**Road vehicles — Test methods
for electrical disturbances from
electrostatic discharge**

AMENDMENT 1

Reference number
ISO 10605:2008/Amd.1:2014(E)

Table A.1 (continued)

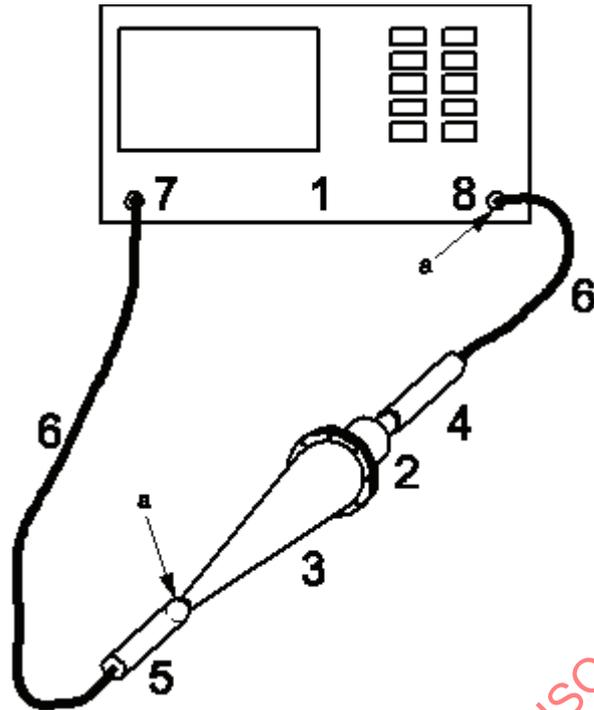
Replace the title of Table A.1: “Contact discharge verification procedure” with “Contact discharge current waveform verification procedure”.

Replace: “output voltage” with “test voltage” and replace: “charge voltage” with “test voltage”.

| Step | Resistance | | | | Explanation |
|--|--|---------------------------------------|---|---|---|
| Check: current at t_1 /test voltage (A/kV) | Check if $\bar{I}_1 = 2 \pm 30 \%$ | Check if $\bar{I}_1 = 2 \pm 30 \%$ | Check if $\bar{I}_1 = 0,275 \pm 30 \%$ | Check if $\bar{I}_1 = 0,275 \pm 30 \%$ | Again, compliance of the ESD gen- erator is verified on the average of the parameter. |
| Check: current at t_2 /test voltage (A/kV) | Check if $\bar{I}_2 = 1 \pm 30 \%$ | Check if $\bar{I}_2 = 1 \pm 30 \%$ | Check if $\bar{I}_2 = 0,15 \pm 50 \%$ | Check if $\bar{I}_2 = 0,15 \pm 50 \%$ | Again, compliance of the ESD gen- erator is verified on the average of the parameter. |
| Check: peak current/test voltage (A/kV) | Check if $\bar{I}_p = 3,75 \pm 10 \%$ | | Check if $\bar{I}_p = 3,75^{+30}_0 \%$ | | Again, compliance of the ESD gen- erator is verified on the average of the parameter. |
| Check rise time | Check if $0,7 \text{ ns} \leq \bar{t}_r \leq 1 \text{ ns}$ | | | | |

Figure B.8 — Network analyser measurement of the insertion loss of a current target-attenuator-cable chain

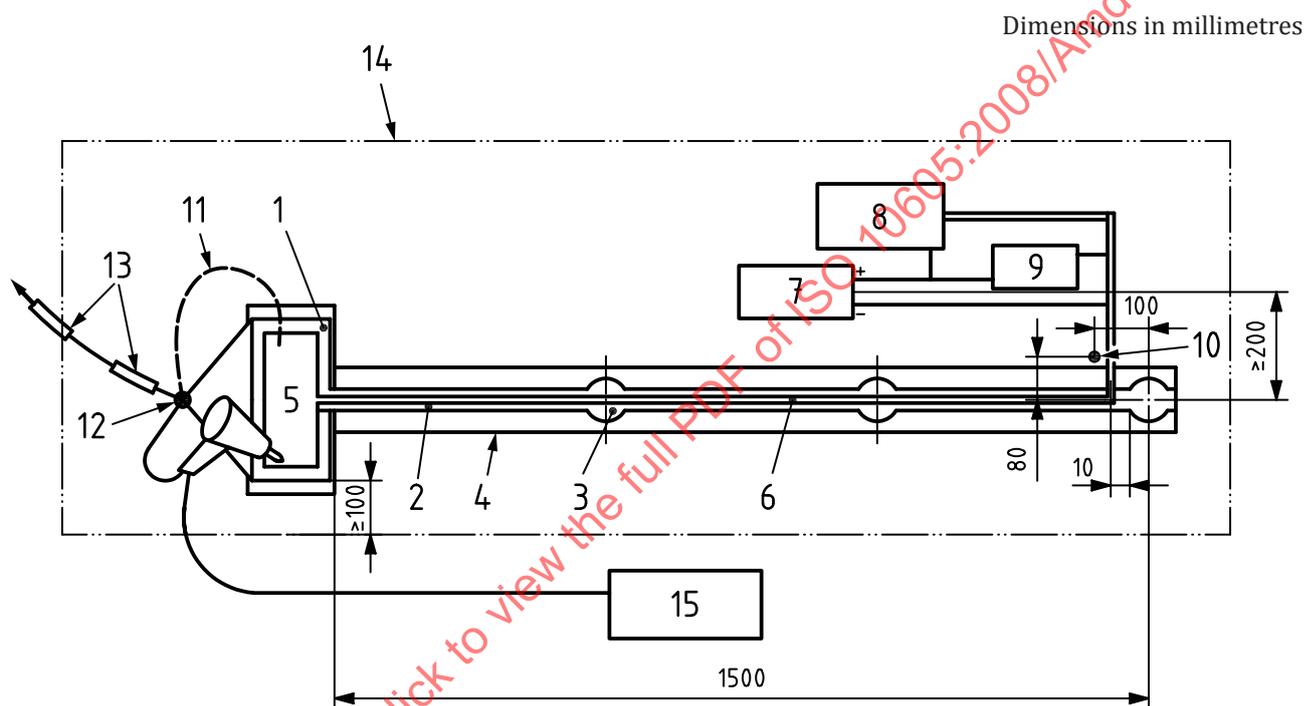
Add to Figure B.8, key item 6, the following text: “(between attenuator A and network analyser and between attenuator B and network analyser)”.

In B.2.3, in the paragraph following Figure B.8, delete: “(between attenuator and target and between attenuator and target adapter line)”.

| 2 | ESD current target | 6 | coaxial cable (between attenuator A and network analyser and between attenuator B and network analyser) |
